# Texas Commission on Environmental Quality

Facility Name: City of Waco Transfer Station Facility

August 15, 2023  
SCS Project No. 16222063.00

Subject: Subchapter T Development Permit Application for Enclosed Structure  
New Building for MSW Transfer Station at City of Waco Landfill, MSW Permit No. 1039  
Proposed Development Permit Application No. - TBA  
Response to Notice-of-Deficiency (NOD) Email, Dated July 25, 2023  
McLennan County, Texas.  
Tracking No. 28604235; RN TBA/CN600131940

METHANE BARRIER DETAILS  
NTS

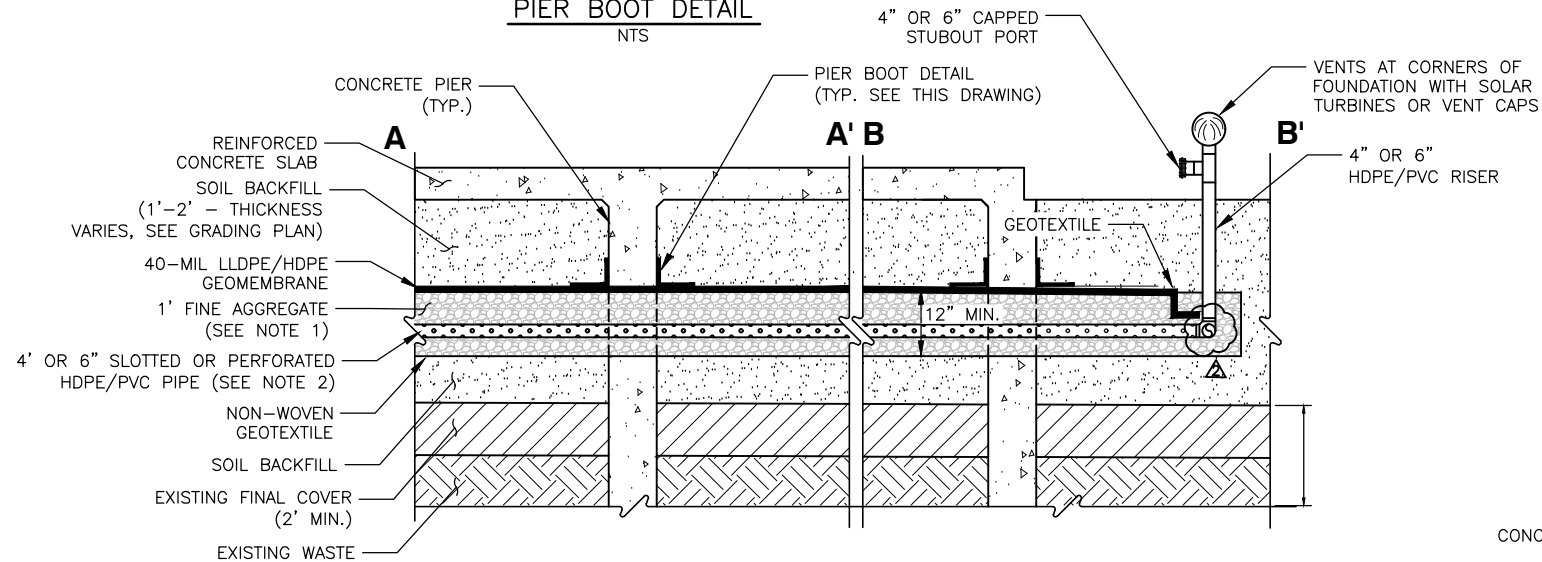
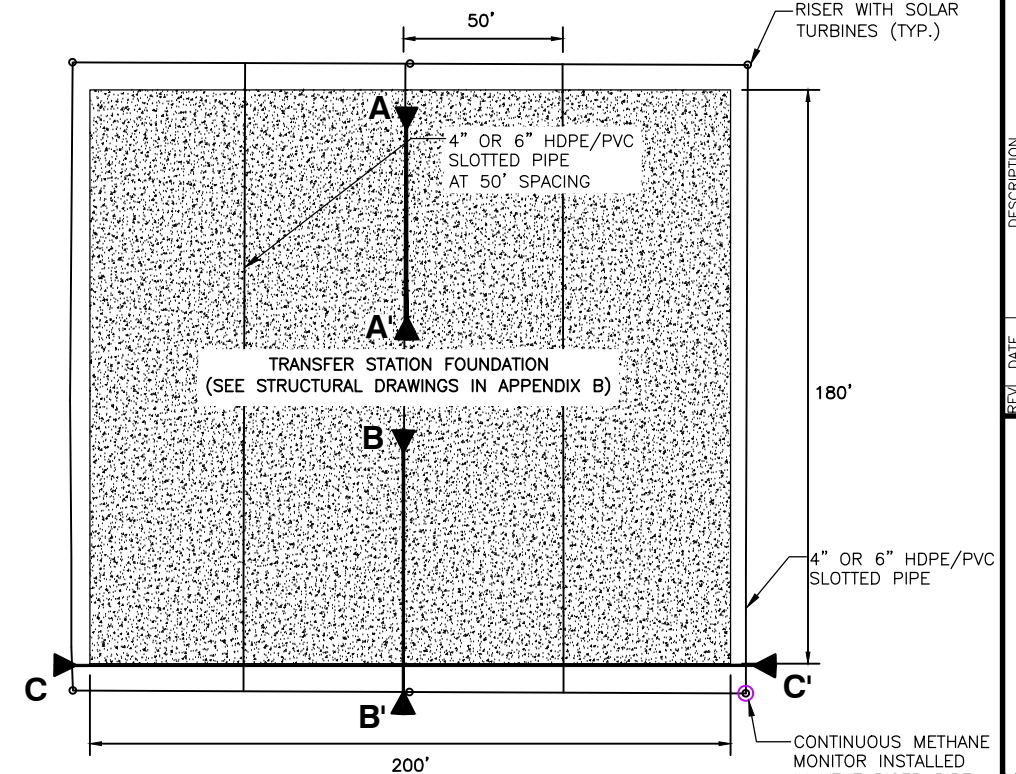
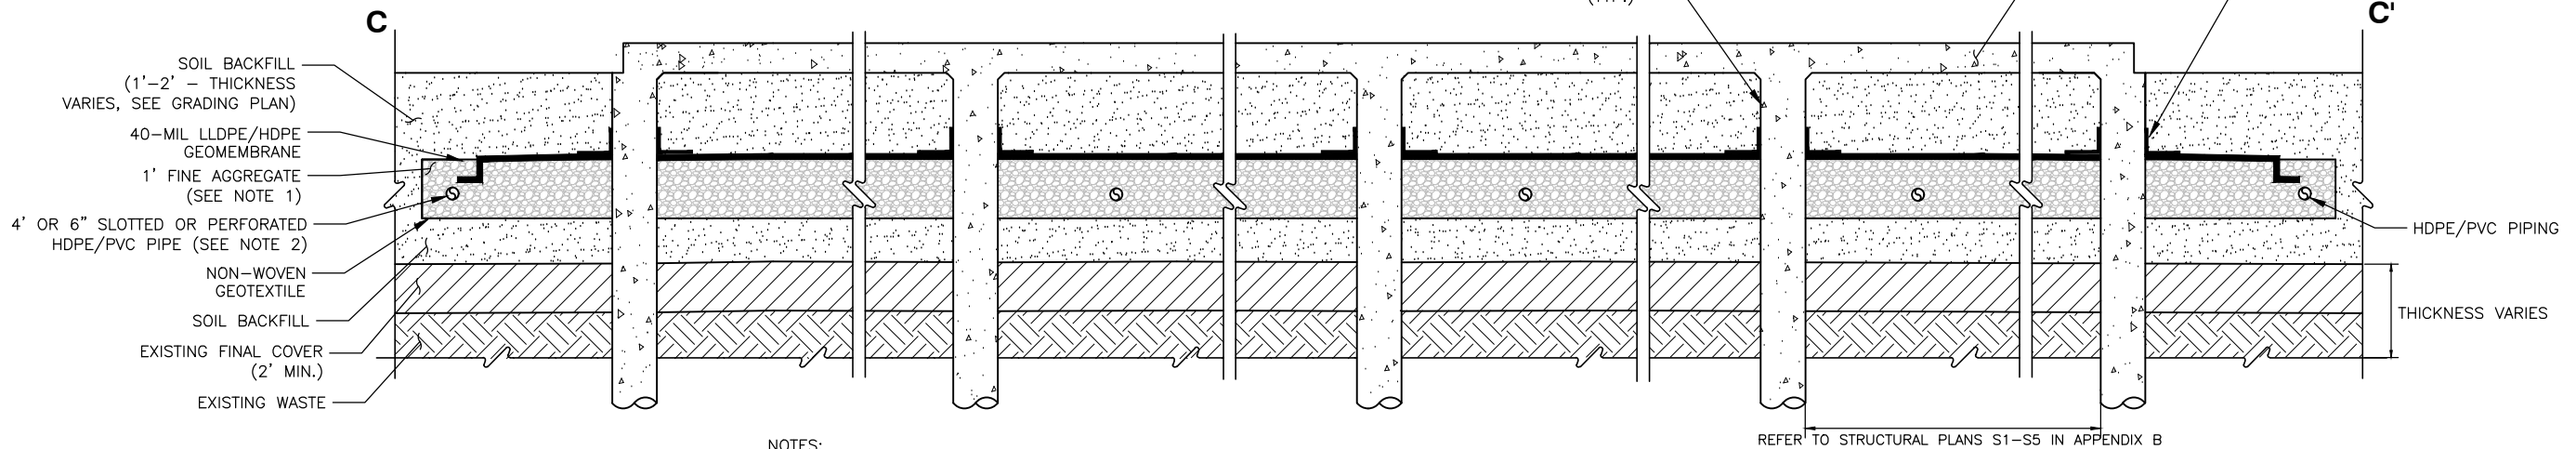
5. Section 13, Foundation Plans, Note 1, indicates permeable layer specification as coarse sand or fine gravel. Revise the material to be open-graded consistent with 30 TAC 330.957(m)(1)(A).

9. Provide a cross-section along the edge of the foundation. Cross section B-B' does not seem to be representative of the intended drawing section. Indicate the thickness of the fill material above the 40-mil LLDPE/HDPE Geomembrane.

10. Section 13, Drawing 13.1, provide backfill material specifications. No excavated waste intermixed with soil shall be used as soil backfill.

***The note 1 on drawing 13.1 has been revised to include the requested change.***

***A new cross section has been added to Drawing 13.1 along the edge of the foundation, as requested. The existing cross sections A-A' and B-B' on Drawing 13.1 are representative of the transfer station building foundation, but has been revised to clarify the thickness of soil fill above the 40-mil LLDPE/HDPE geomembrane per your request.***

***Section 3.6 and Drawing 13.1 have been revised to include backfill material specifications, as requested.***

1. FINE AGGREGATE SHALL BE COARSE SAND OR FINE GRAVEL THAT IS AN OPEN GRADED CLEAN MATERIAL.
2. SLOTTED OR PERFORATED PIPING SHALL EXTEND AROUND THE BUILDING PERIMETER AND BENEATH SLAB AS SHOWN ON PIPING PLAN DETAIL.
3. PROVIDE FITTED HDPE BOOTS FOR A1C FOUNDATION PIERS (SEE PIER BOOT DETAIL, THIS SHEET)
4. CONTINUOUS METHANE MONITORS SHALL BE INSTALLED IN THE VENT PIPE RISER. REFERENCE PIPING PLAN (THIS PAGE) FOR VENT RISERS AND METHANE MONITOR LOCATIONS.
5. PROVIDE 4" OR 6" CAPPED PORT FOR FUTURE BLOWER IF NEEDED.
6. PIERS SHALL EXTEND INTO UNDERLYING BEDROCK AS INDICATED ON STRUCTURAL PLANS S1-S5 IN APPENDIX B.
7. EXCAVATED WASTE THAT IS MIXED WITH SOIL SHALL NOT BE USED AS SOIL BACKFILL.

## October 2022 Methane Investigation and Boring Plan

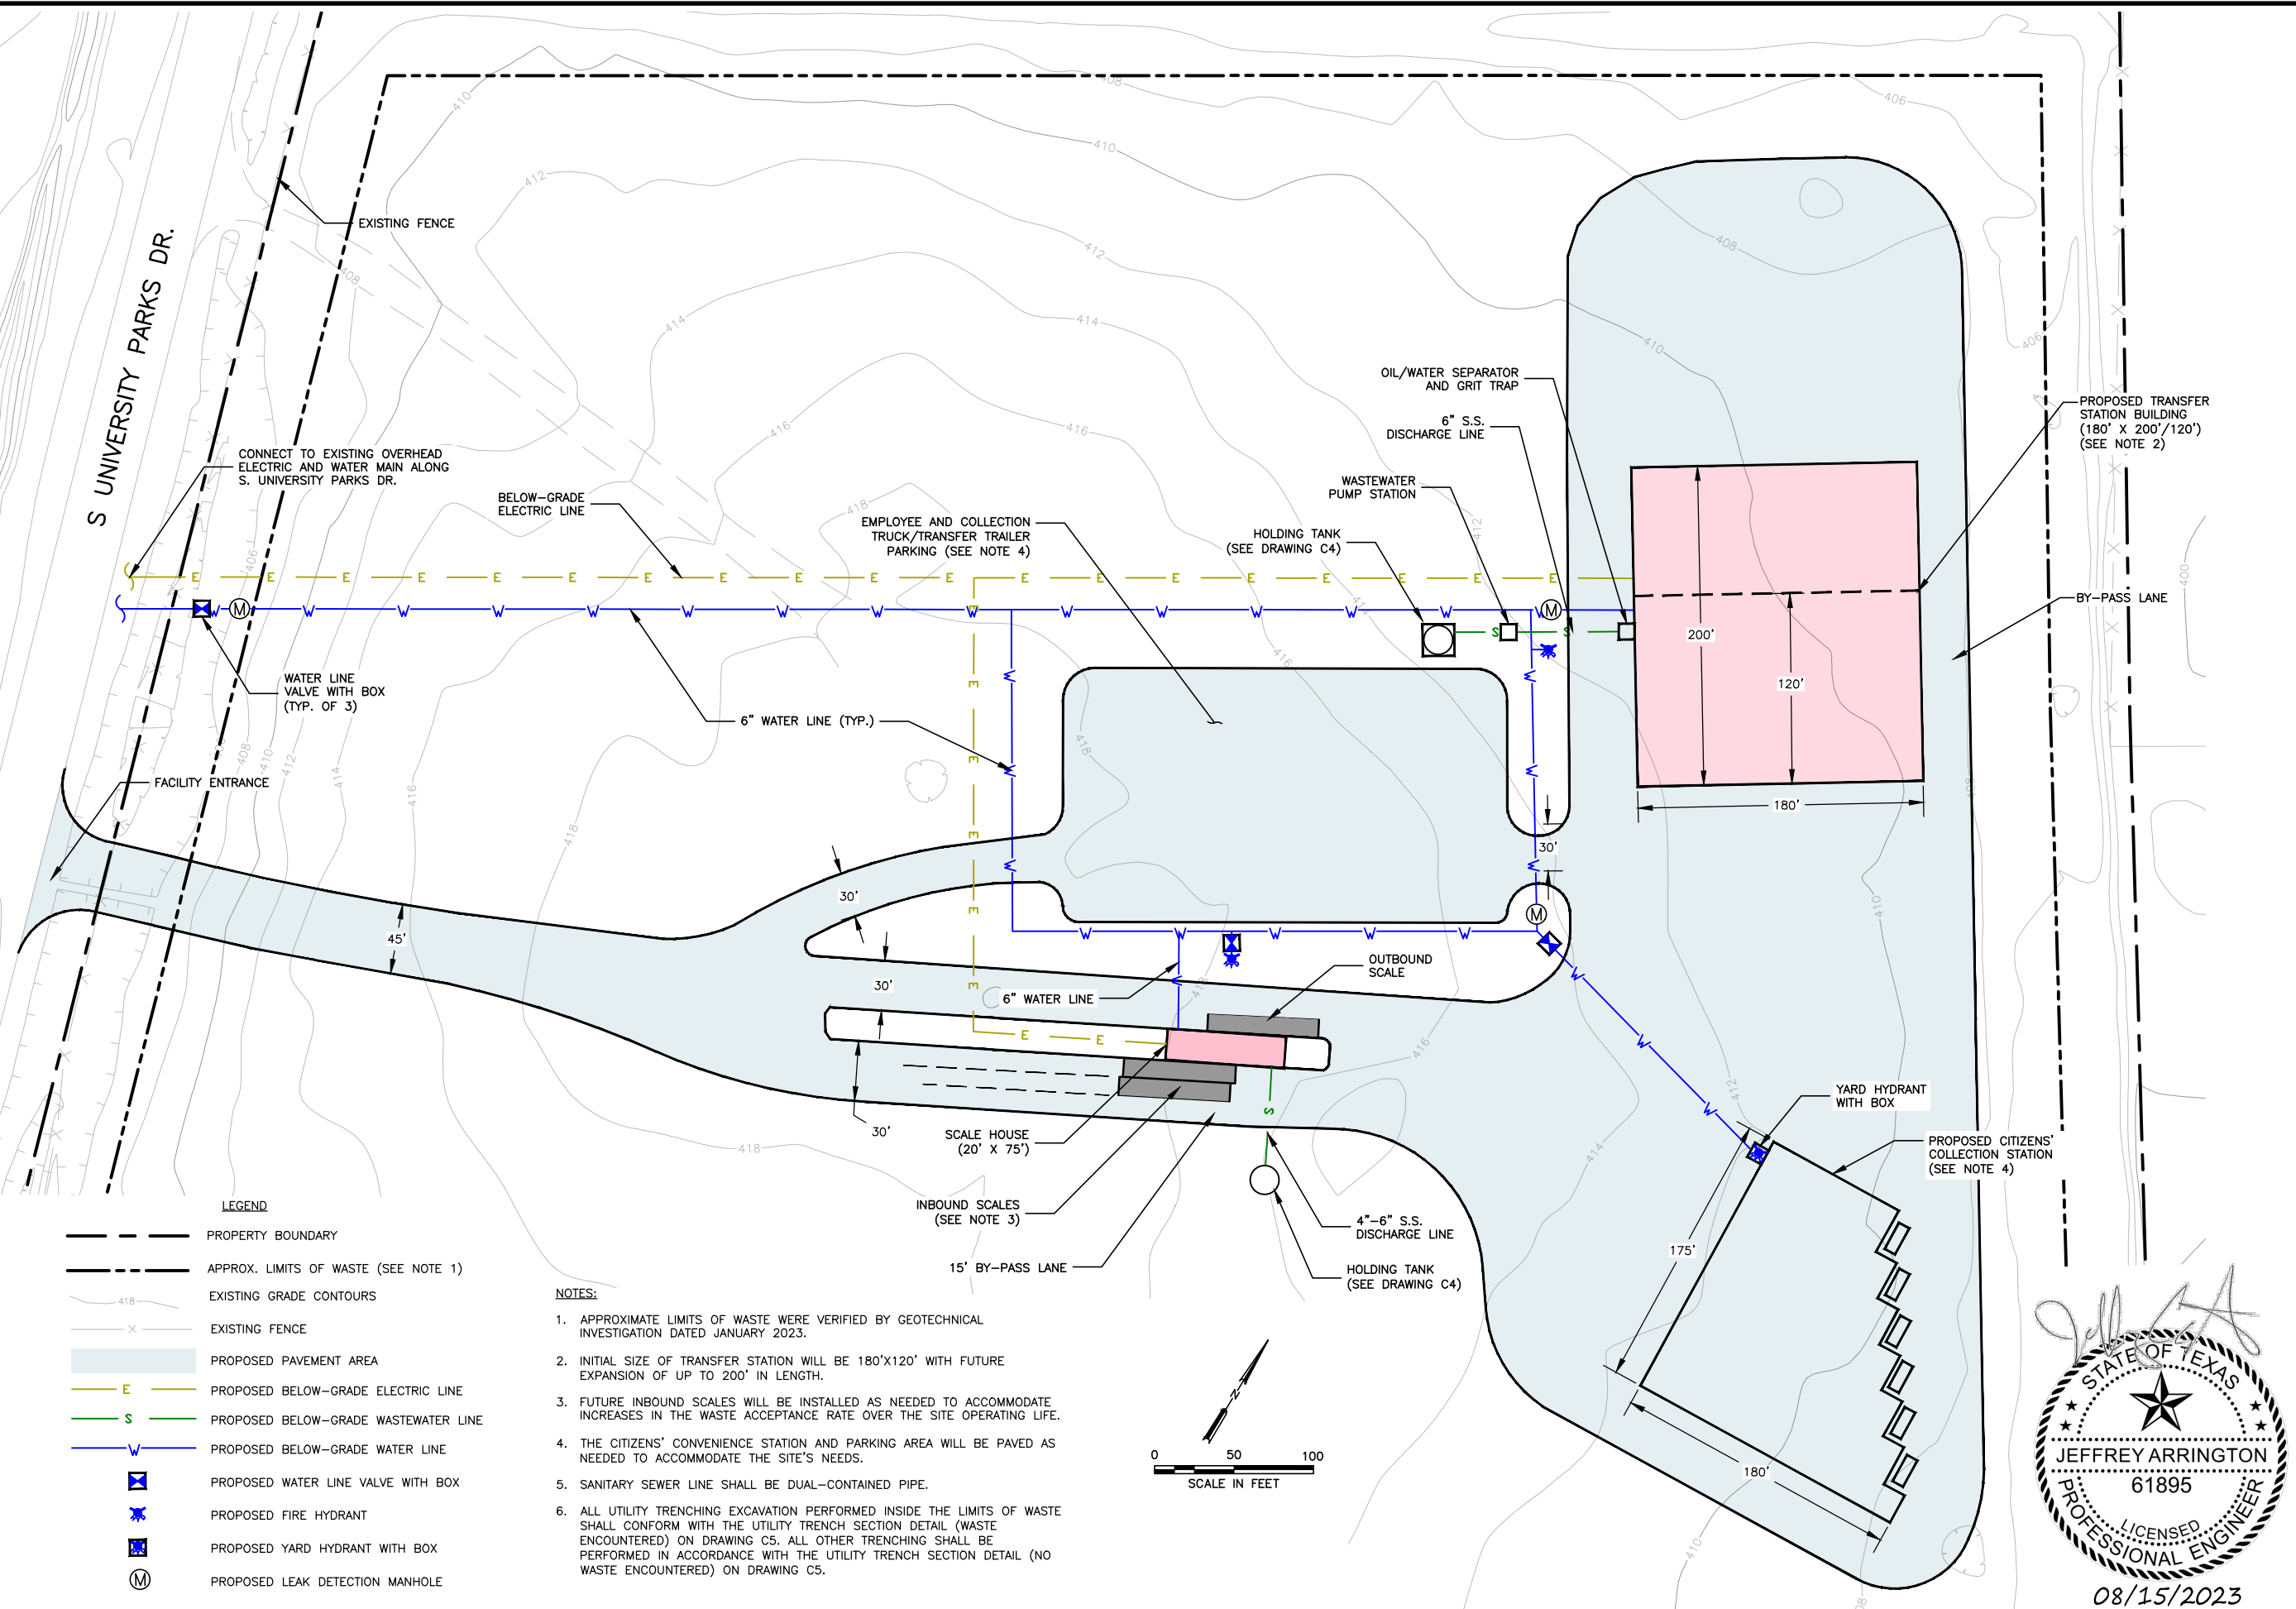
1. Section 3.5, Gas Production Potential, indicates landfill production is expected to continue at low to moderate levels in the near future. Provide additional information and explain if a landfill methane gas survey has been conducted at the site to validate the amount of methane present.

***A methane gas investigation of the closed landfill site was performed during the geotechnical investigation in October 2022. As such, the Section 3.5 has been revised to include the additional information requested and the results of the methane gas investigation have been included in Appendix A.***

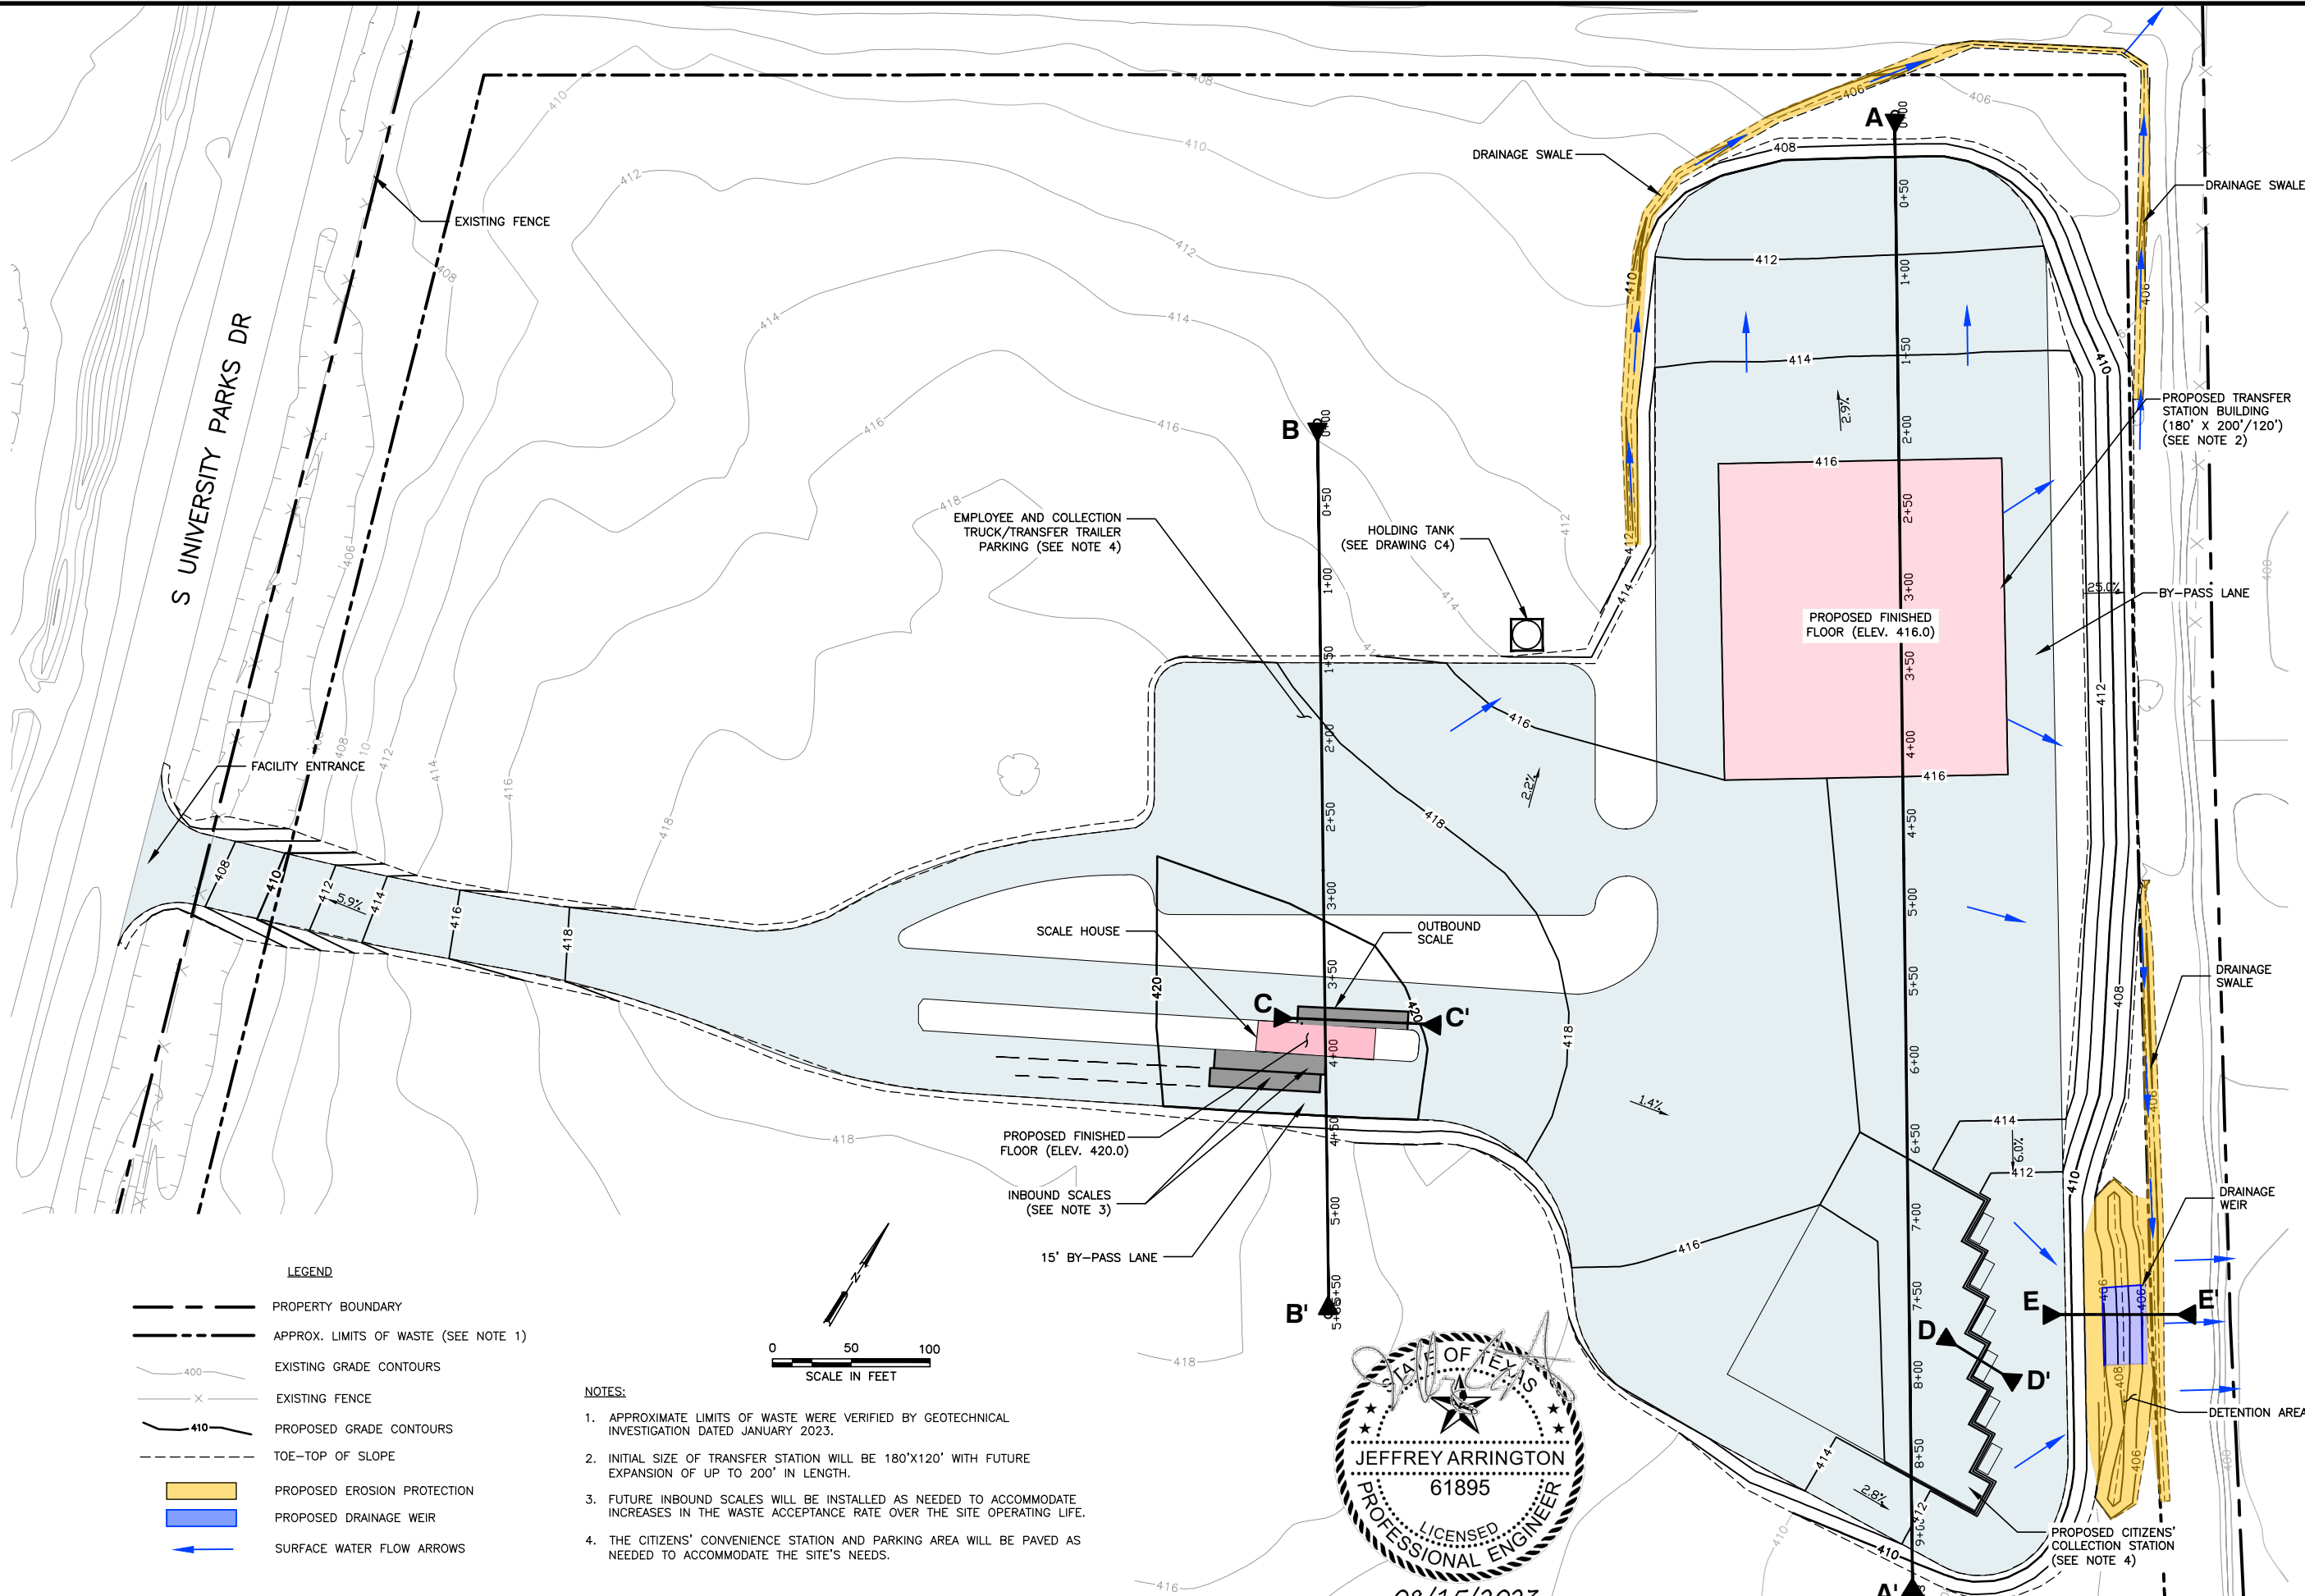
15. Indicate the location of the holding tank in Drawing C2.

***The location of the holding tank has been added to Drawing C2, as requested.***
